**RECORD OF DECISION  
ASARCO GLOBE PLANT SITE  
DENVER, COLORADO**

**SUPPLEMENTAL  
RECORD OF DECISION**

Colorado Department of Health  
4300 Cherry Creek Drive South  
Denver, Colorado 80222

February 18, 1993

Figure 6 Groundwater Plume Map

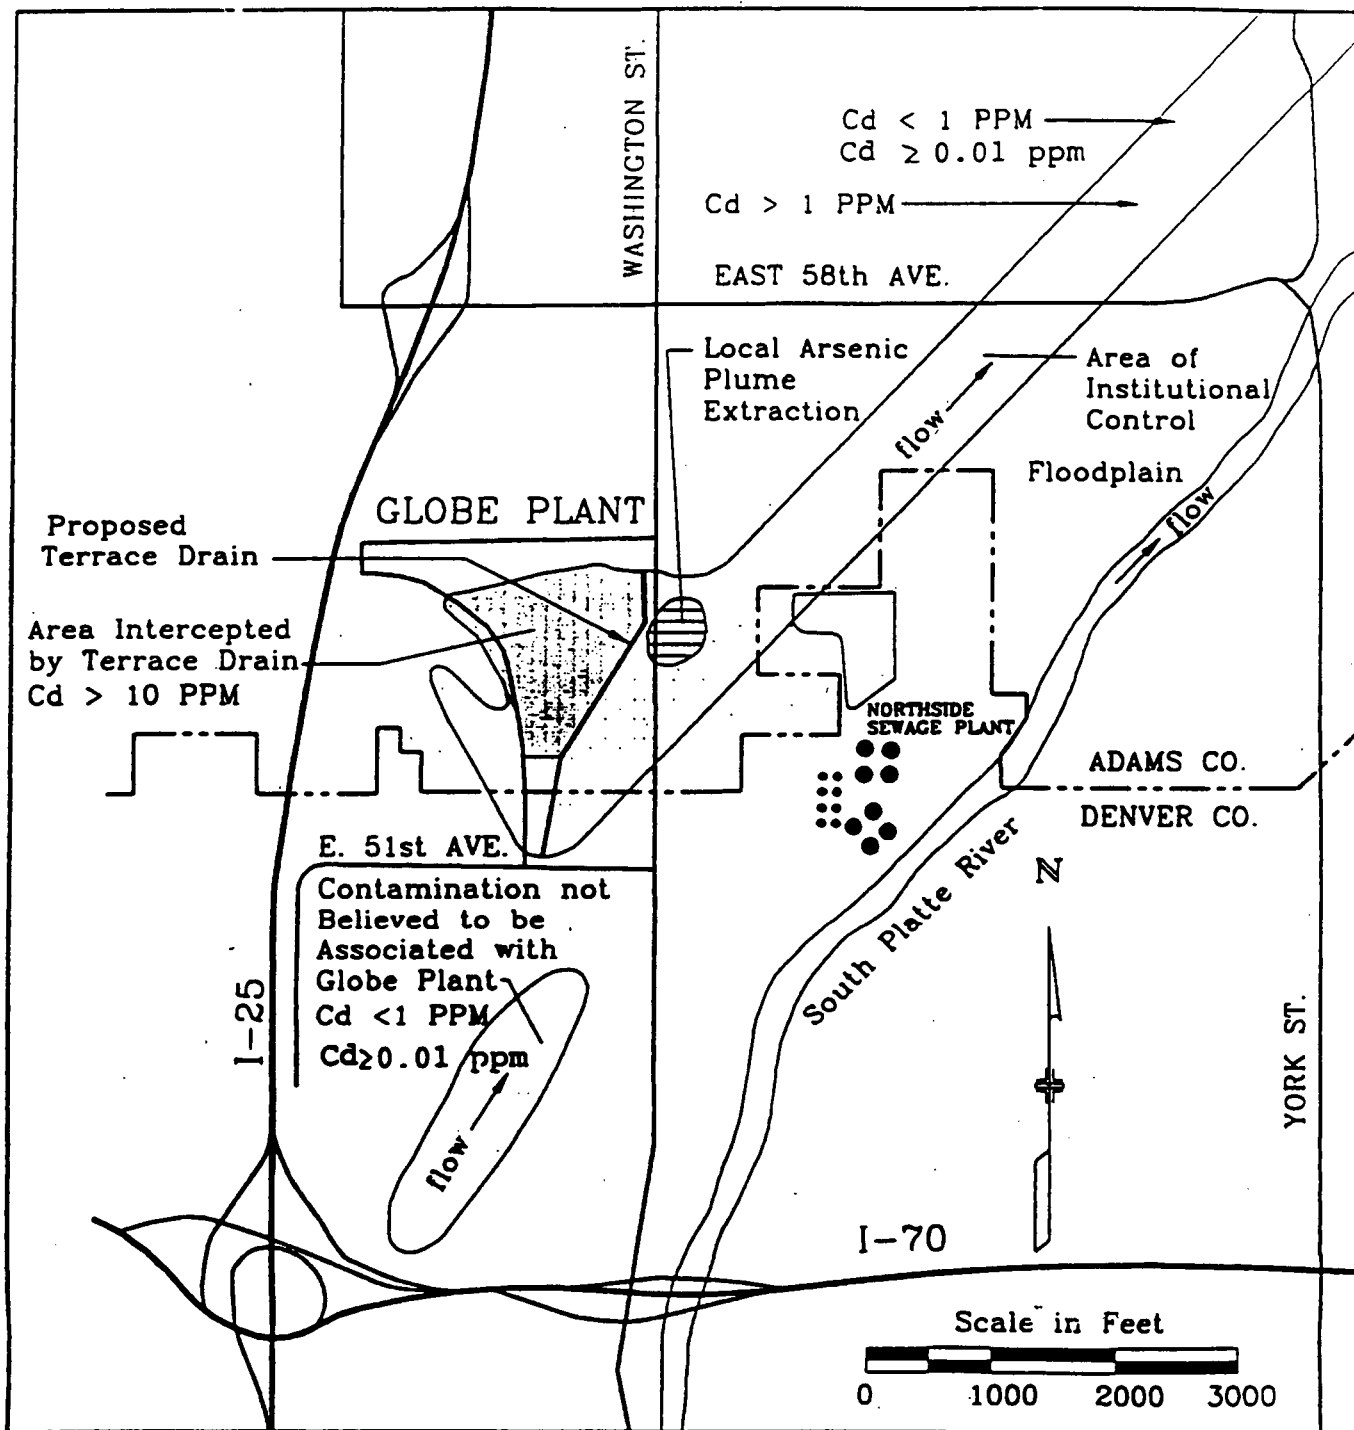
**6. Figure 2 of the Proposed Plan, labeled "Ground Water Plume Map," seems to indicate that the suspected ground water plume may skirt the edge of the DHA property before turning away to the northeast. The Proposed Plan lacks sufficient detail on this point. In addition, the schedule for the proposed site remedy for groundwater is unclear. Again, cleanup should be accelerated wherever possible.**

Figure 8 Community Soils Cleanup

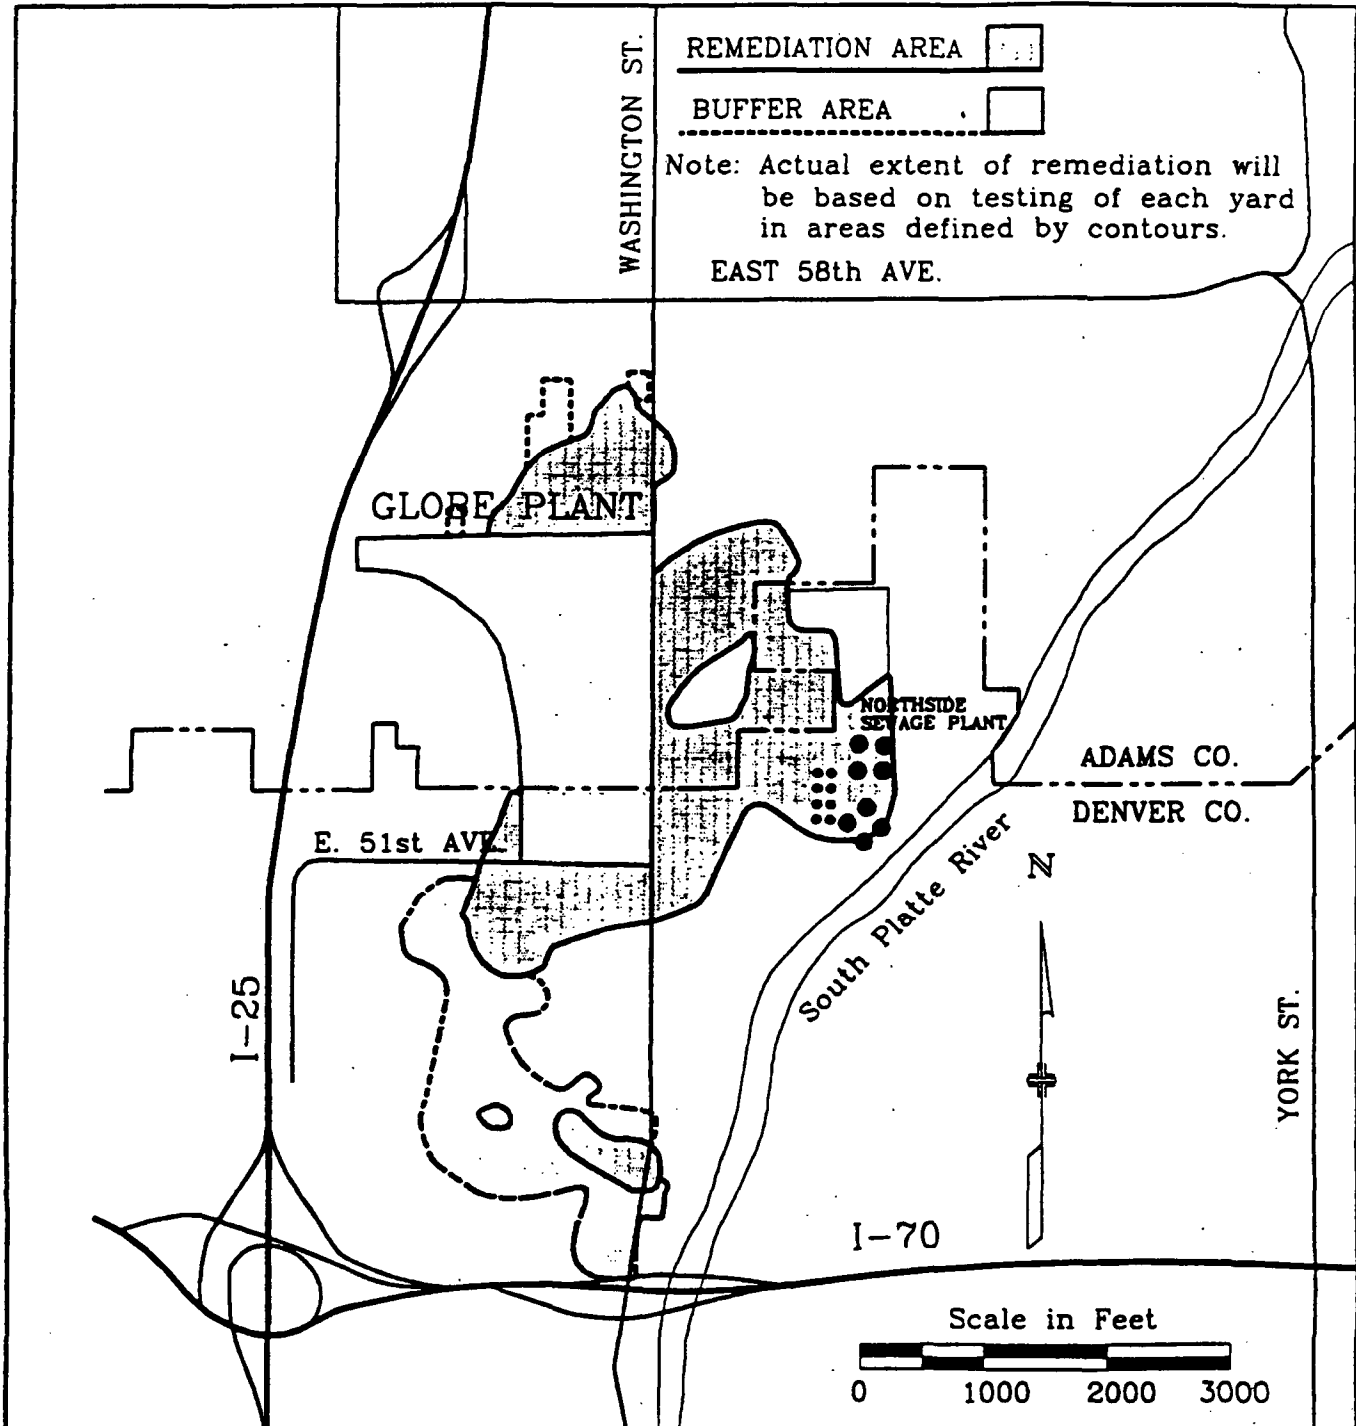
- 3. It is not clear from figure 5, labeled "Community Soils Cleanup," whether DHA's entire property is included in the area slated for additional sampling and possible cleanup. DHA has been informed that the DHA tract is included in soil sampling plans. The figure and accompanying text must be amended to make this absolutely clear. While initial data indicates that soil levels of cadmium, arsenic and lead on the DHA property may be below action levels contained in the proposed Plan, further confirmatory sampling is warranted.**

**The property of 260 E. 54th Corporation (Corporation) constitutes approximately six acres. Based upon our review of the Proposed Plan, particularly Figure 5 on the Community Soils Cleanup, it is unclear whether any soils sampling was done to the west of the Globe Plant in the vicinity of the property of the Corporation. The Industrial Drainage Ditch does cross the property, and the Proposed Plan contemplates that cleanup work will be done on the ditch.**

Figure 5 of the Proposed Plan is based upon the soil sampling conducted during the RI/FS and is not intended to describe the exact boundaries slated for cleanup. Rather, it is intended to show general contaminant patterns and the general area where additional sampling will be necessary to confirm whether remediation is necessary. Decisions regarding whether properties will require cleanup should not be made based upon Figure 5; these decisions should be made based upon sampling conducted on the individual property. Additional property-specific sampling will be conducted to further delineate the edges of cleanup areas. While the sampling conducted in the RI/FS was sufficient to describe contaminant patterns, we will need to confirm the boundary of cleanup through additional sampling. Where properties appear to be near the "edge" of the cleanup area, additional sampling will be conducted until the edge of the cleanup area is more clearly defined. We plan to sample the width of a standard city block, 660 feet, beyond any area found to be contaminated above action levels in order to confirm this "edge".

Figure 5 of the Proposed Plan is based upon the soil sampling conducted during the RI/FS and is not intended to describe the exact boundaries slated for cleanup. Rather, it is intended to show general contaminant patterns and the general area where additional sampling will be necessary to confirm whether remediation is necessary. Decisions regarding whether properties will require cleanup should not be made based upon Figure 5; these decisions should be made based upon sampling conducted on the individual property. Additional property-specific sampling will be conducted to further delineate the edges of cleanup areas. While the sampling conducted in the RI/FS was sufficient to describe contaminant patterns, we will need to confirm the boundary of cleanup through additional sampling. More detailed soil contaminant maps can be found in the RI/FS reports.
